ISSUE RESOLUTION STATUS REPORT

KEY TECHNICAL ISSUE: REPOSITORY DESIGN AND THERMAL-MECHANICAL EFFECTS

Division of Waste Management
Office of Nuclear Material Safety and Safeguards
U.S. Nuclear Regulatory Commission

Revision 3

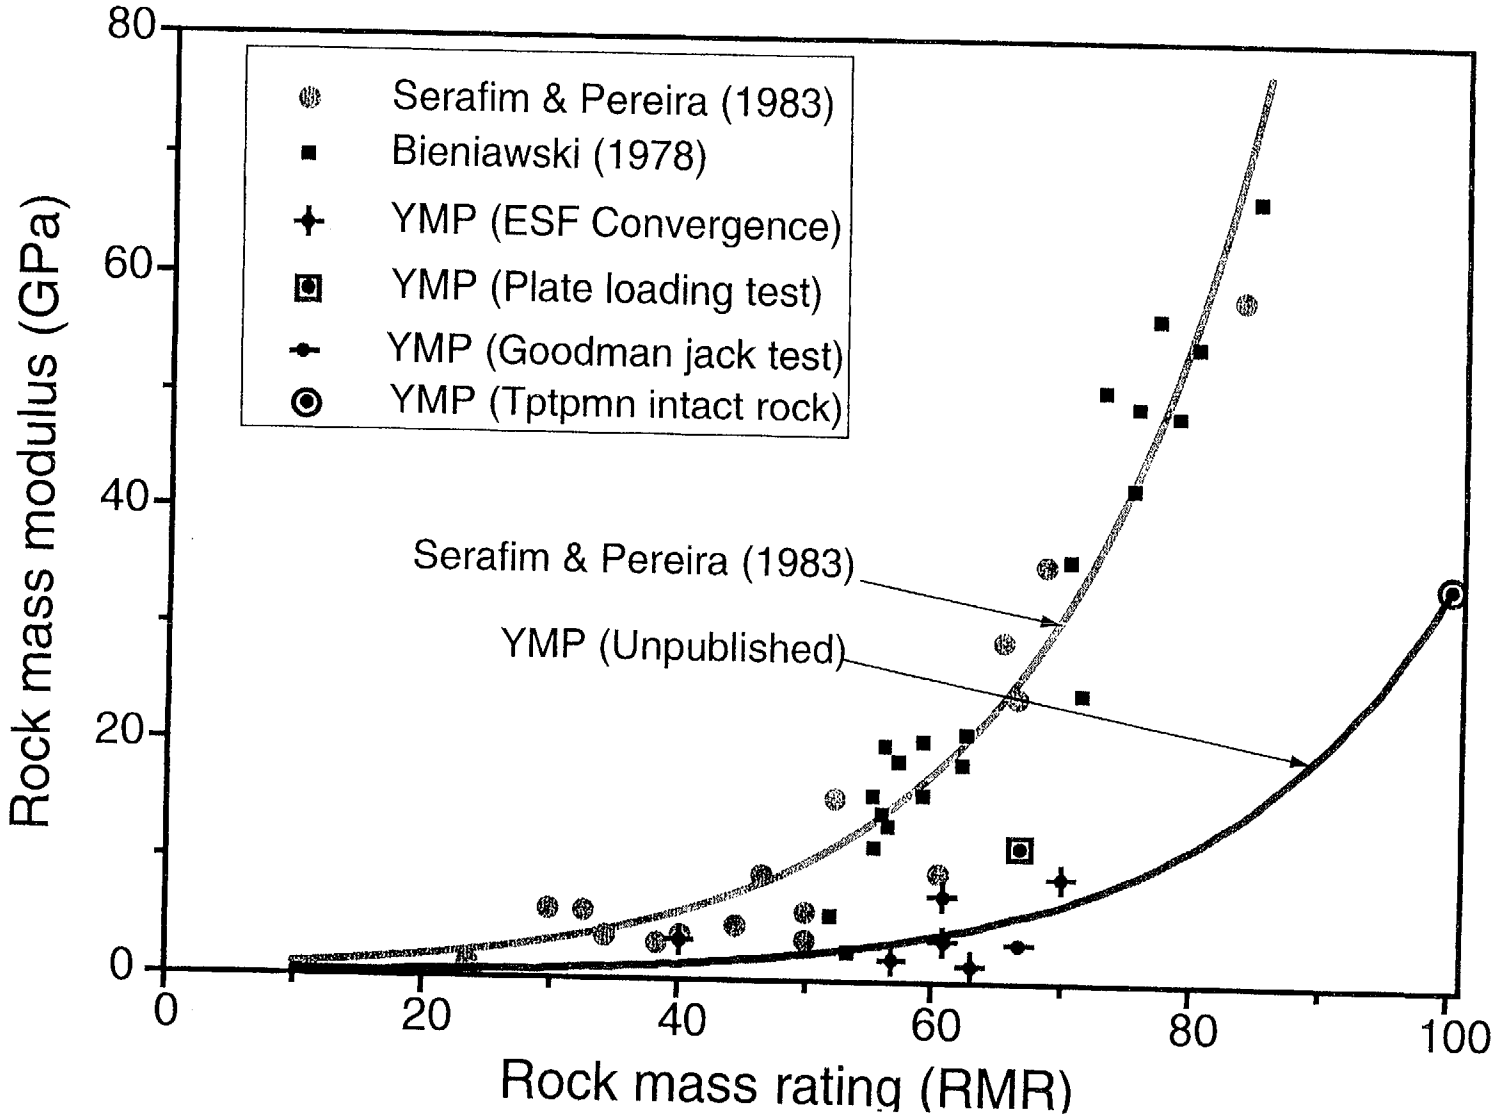
Two sets of empirical E-vs-RMR data available from the literature (Bieniawski, 1978; Serafim and Pereira, 1983) are presented in Figure 3 along with similar data for YM presented at a recent DOE drift stability workshop (Lin, 1998). The figure also shows the Serafim and Pereira (1983) E-vs-RMR curve and a curve suggested for YM in the Lin (1998) presentation. It is important to note that the YMP data in Figure 3 have not been formally published by the DOE. The most recent E data for YM published by the DOE (CRWMS M&O, 1997a), which was used in the ground-support design analyses for the VA (CRWMS M&O, 1998d), were derived using the Serafim and Pereira (1983) relationship. An observation that stands out clearly from Figure 3 is that the YM data are sparse (six data points from ESF convergence analyses and one data point each from the plate-loading and Goodman-jack tests). The available YM data indicate that the Serafim and Pereira relationship may be inappropriate for the YM rock mass, but the data are insufficient to support a determination whether the difference between the YMP and the other two datasets in Figure 3 should be interpreted as a real difference in behavior between different rock masses or as the expected spread of E values [around the Serafim and Pereira (1983) predictions] at low to medium RMR values. The approach of attempting to fit the YMP data to a curve anchored at the intact-rock modulus (i.e., at RMR of 100), as illustrated in Figure 3, may not be appropriate. The shape of the E-vs-RMR curve for rock-mass qualities close to intact rock may significantly differ from the shape at low to medium qualities. In fact, laboratory data on the effect of microcracks on intact-rock stiffness (e.g., Ofoegbu and Curran, 1992) suggest that the stiffness of

a rock mass would approach the intact-rock stiffness asymptotically as the rock-mass quality approaches intact rock. Therefore, because the shape of the *E*-vs-RMR curve may change significantly within the full range of rock-mass quality from lowest qualities to intact rock, it would be misleading to extend an *E*-vs-RMR curve beyond the range of the available rock-mass quality data. The YMP should develop a sufficient number of data points to firmly establish the *E*-vs-RMR (or *Q*) relationship at YM over the range of rock-mass quality values encountered at the site, if it intends to use this approach in the design.

Figure 16. Simulated rockfall after 100 years of thermal loading and one episode of dynamic ground-motion for two slightly different fracture patterns

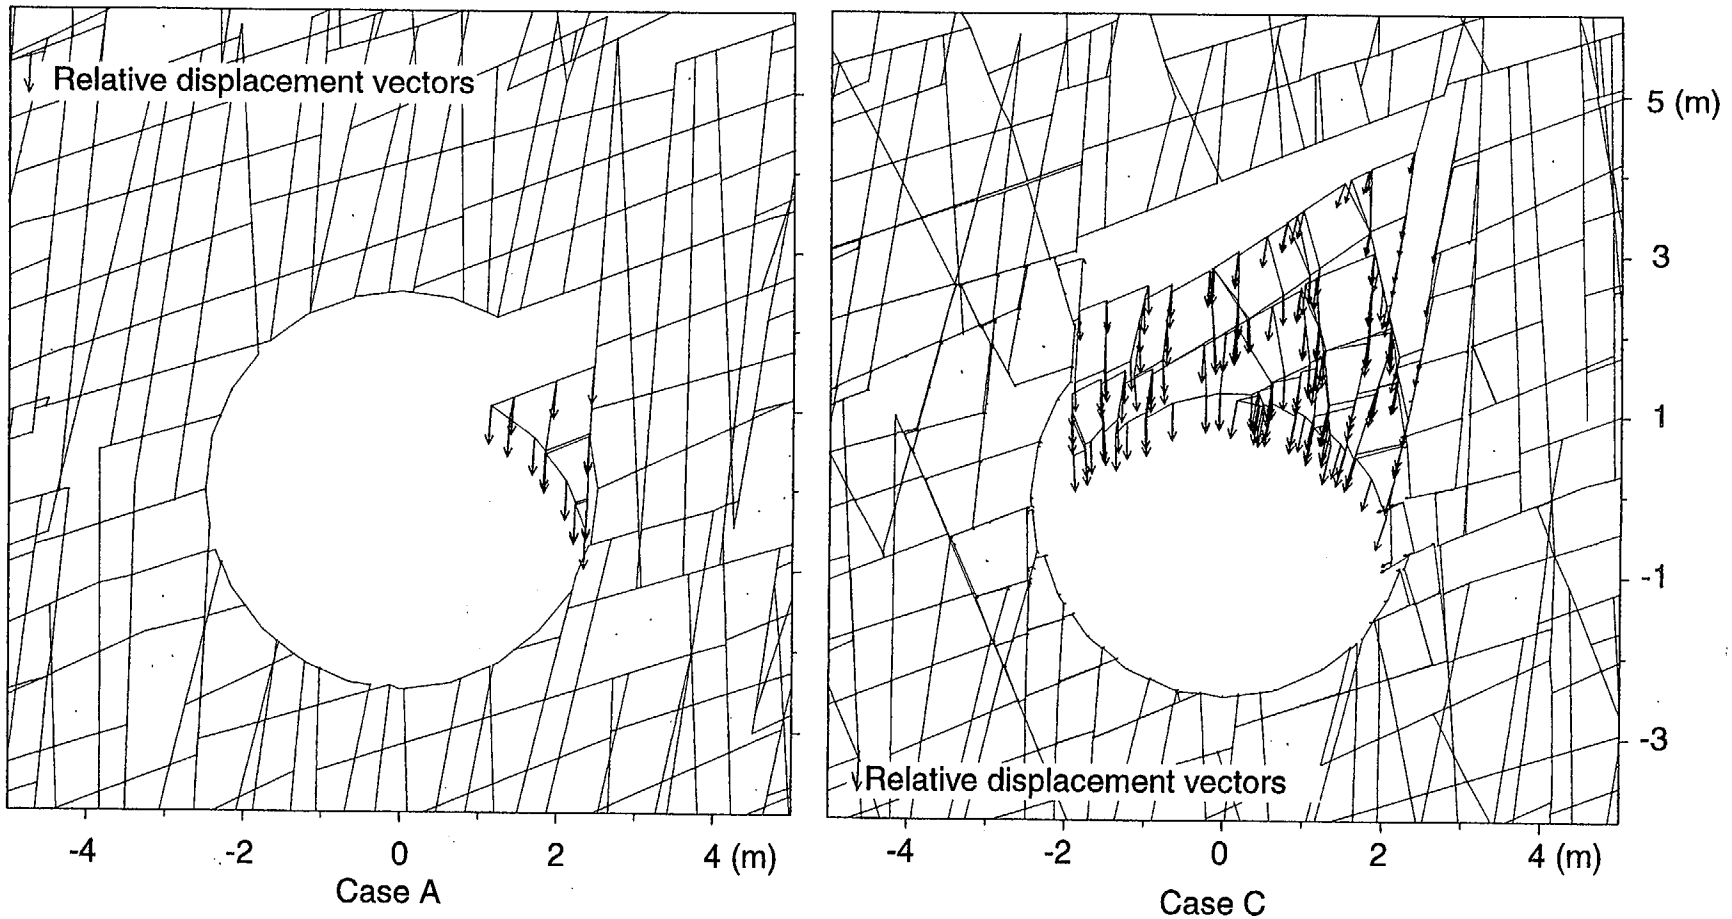
Dynamic modeling results (Chen, 1998; 1999) show that of all these factors, fracture pattern may have the most significant effect on rockfall. Therefore, analyses using a regular fracture pattern such as the one shown in Figure 16 may not be conservative. An ongoing effort at CNWRA is to simulate fracture network patterns representative of the *in situ* conditions based on mapping and scanline data from the ESF and Cross Drift. Future dynamic analyses will incorporate more realistic fracture patterns and recent changes in DOE repository design.

Figure 19. Damage level versus peak ground velocity

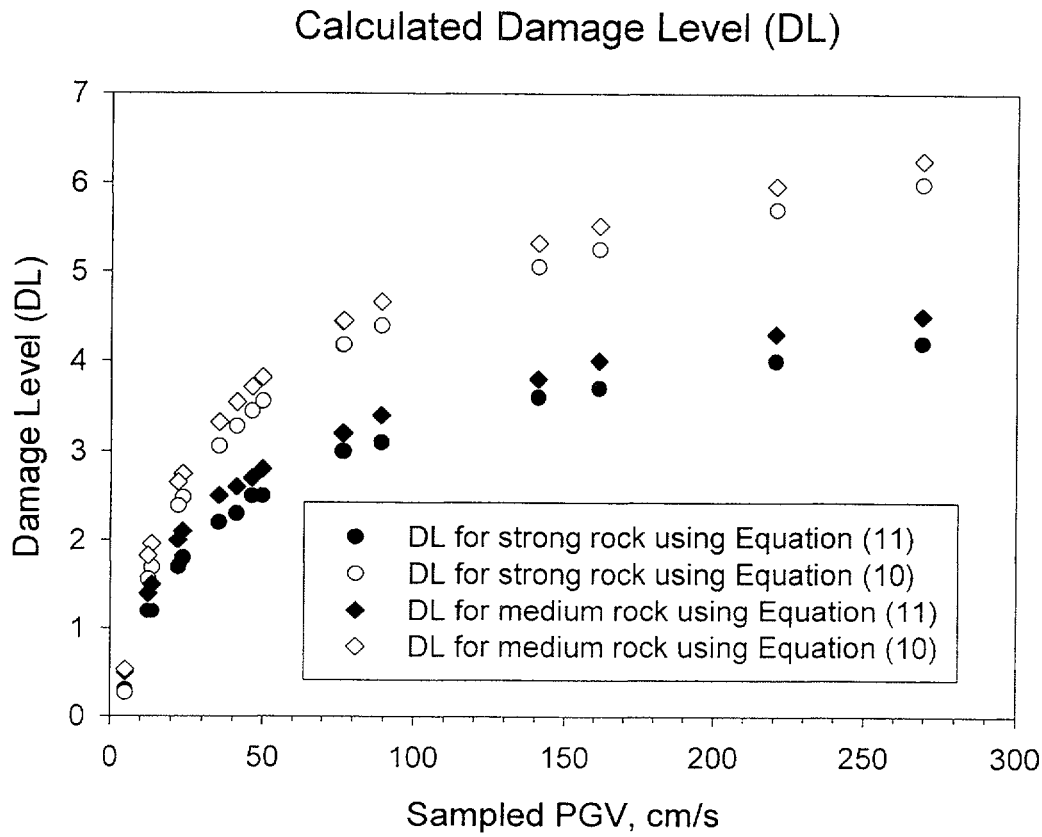
Figure 19 graphically shows the difference of *DL* values calculated for various peak ground velocity (PGVs) using these two equations. The calculated *DL* value is about 40 percent smaller for strong rock and about 30 percent smaller for the medium rock if Eq. (11) is used. It is not clear which equation was intended to be used in the TBD. If Eq. (11) is the correct equation, DOE needs to provide justification. If the use of Eq. (11) is a mistake, this mistake needs to be corrected and the rockfall effect on WP damage reevaluated.
